1 SITE PLAN
A001 1" = 20'-0"

Signature and Seal		
Project		
OSH Albuquerque West Central Plaza 4208 CENTRAL AVE SW ALBUQUERQUE, NM 87107		
Sheet Title		
SITE PLAN		
Date		
03/29/2021		
Scale	Drawn	Project No.
1" = 20'-0"	SG	565
Sheet No.		
A001

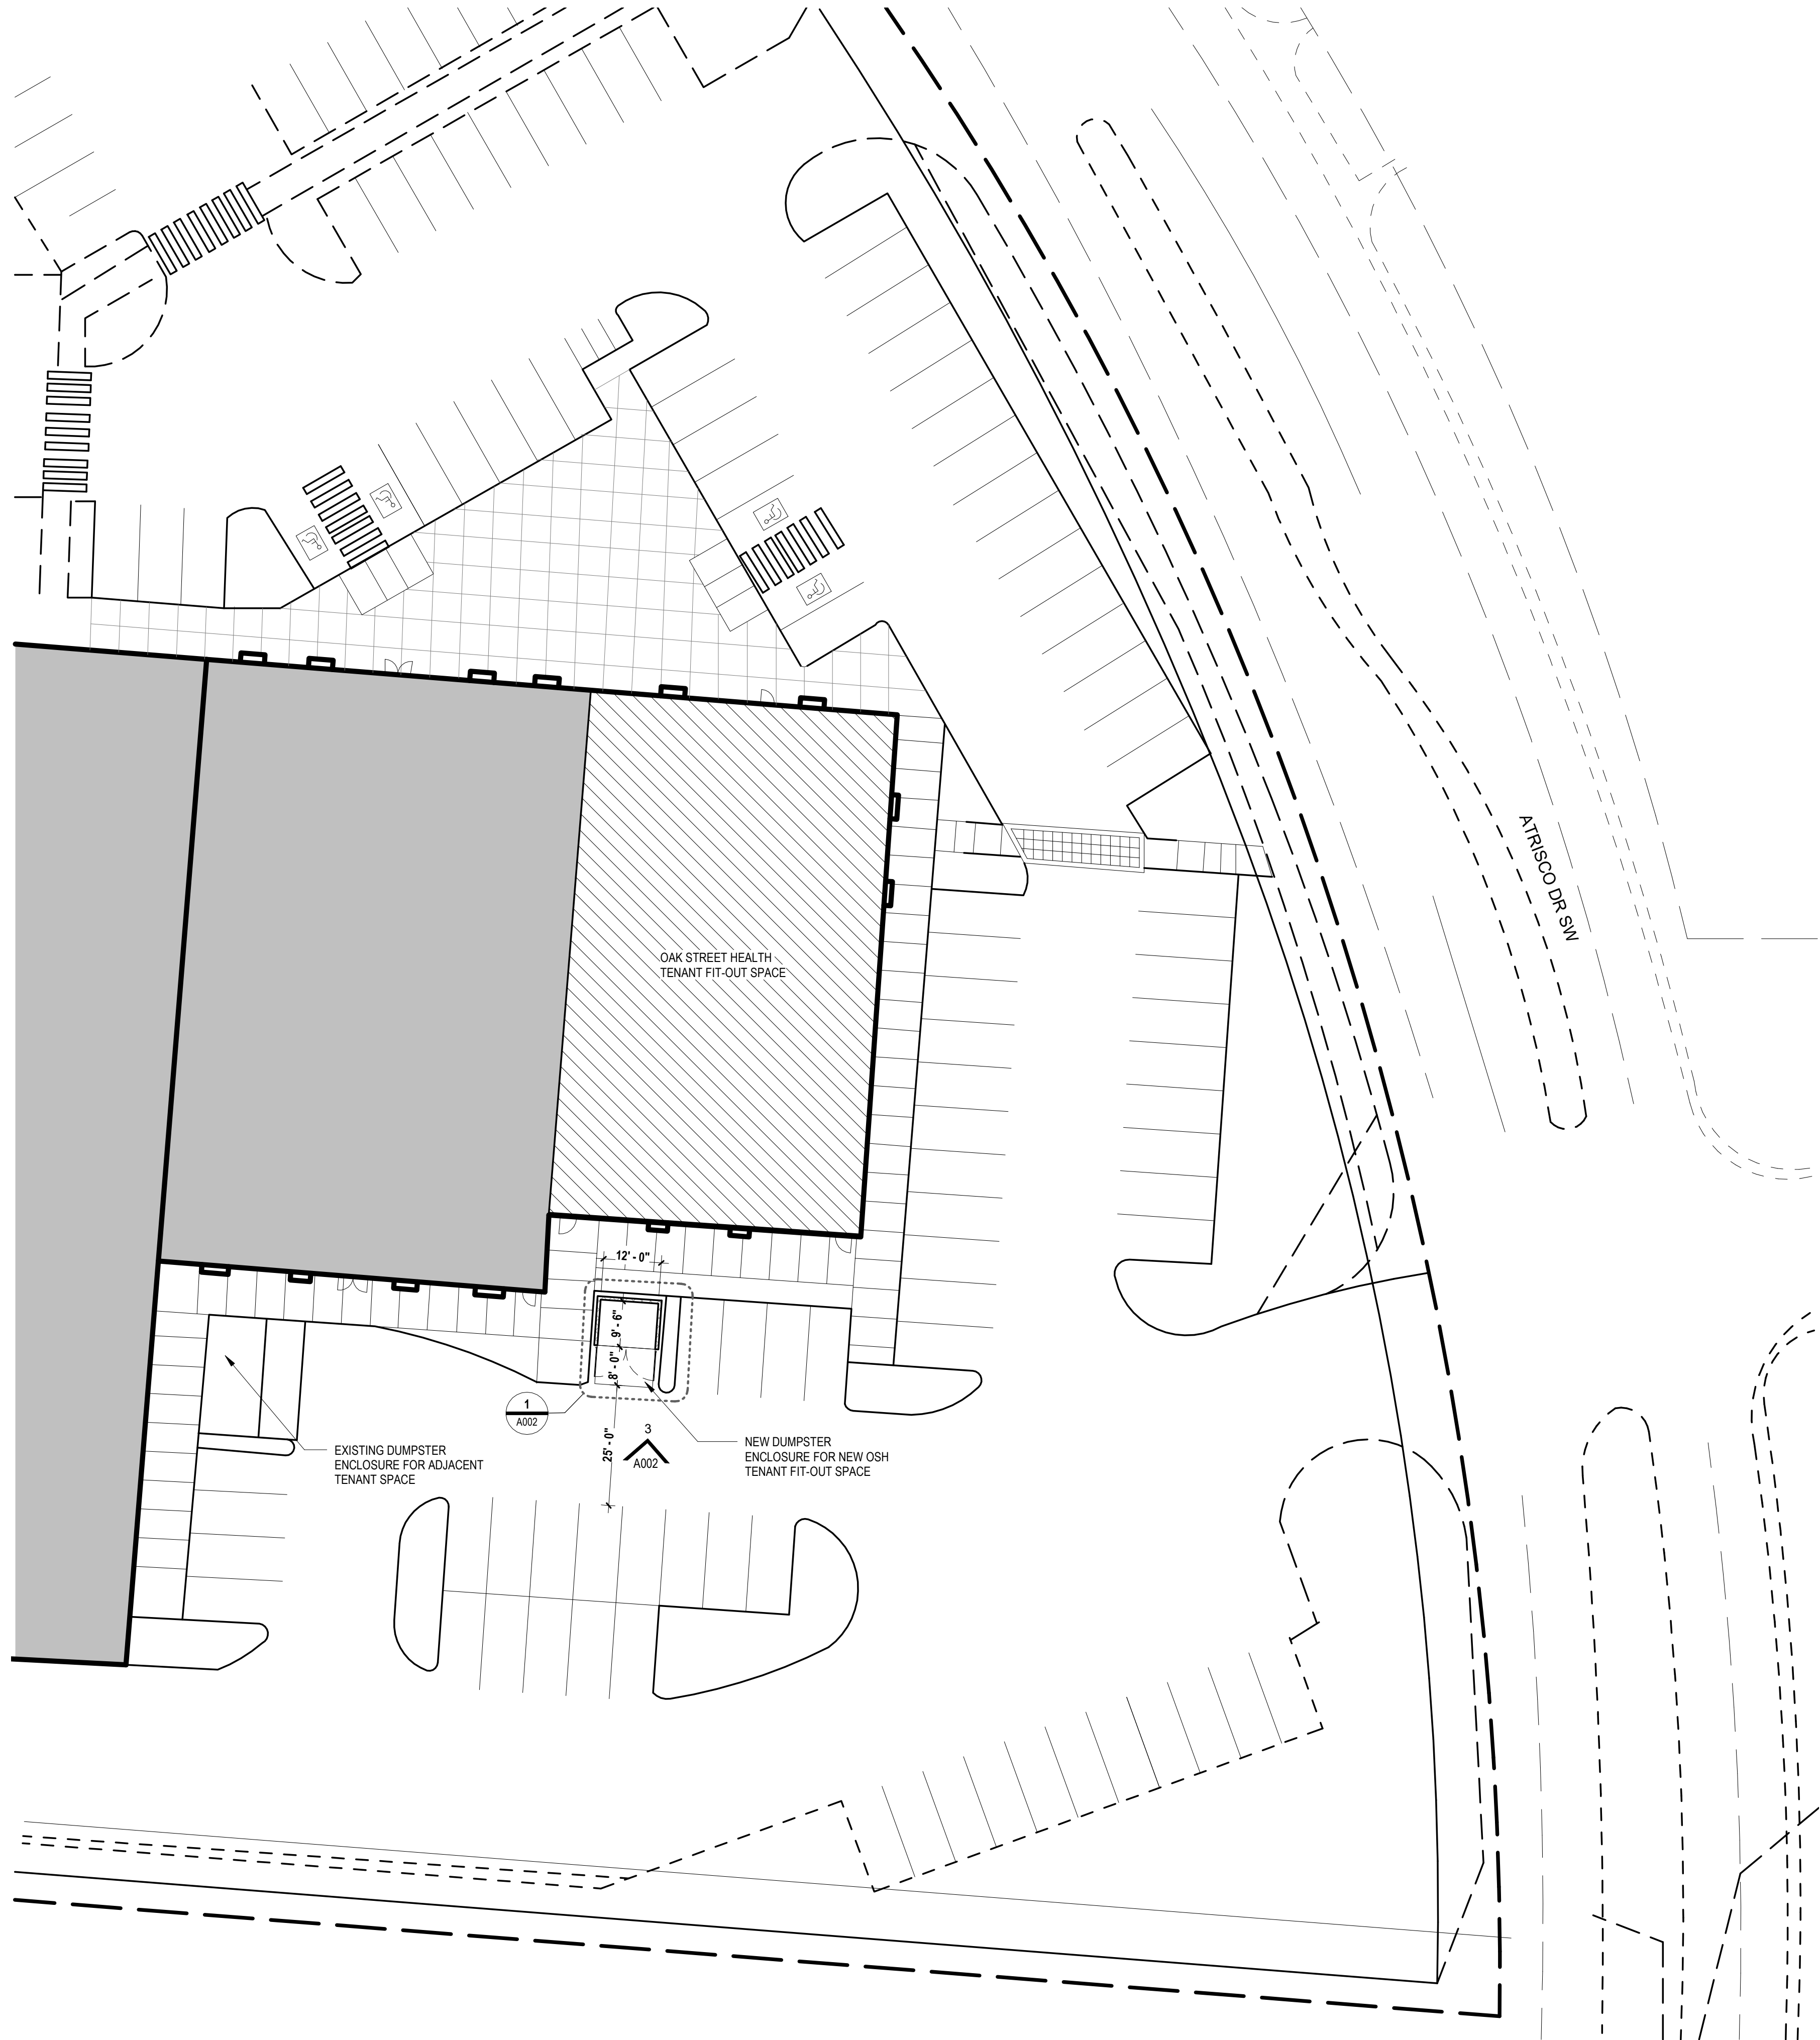
SOLID WASTE DEPARTMENT APPROVAL FOR ACCESS WILL BE APPROVED ONLY FOR A 4YARD LIFT ON CASTERS.
7-8-21
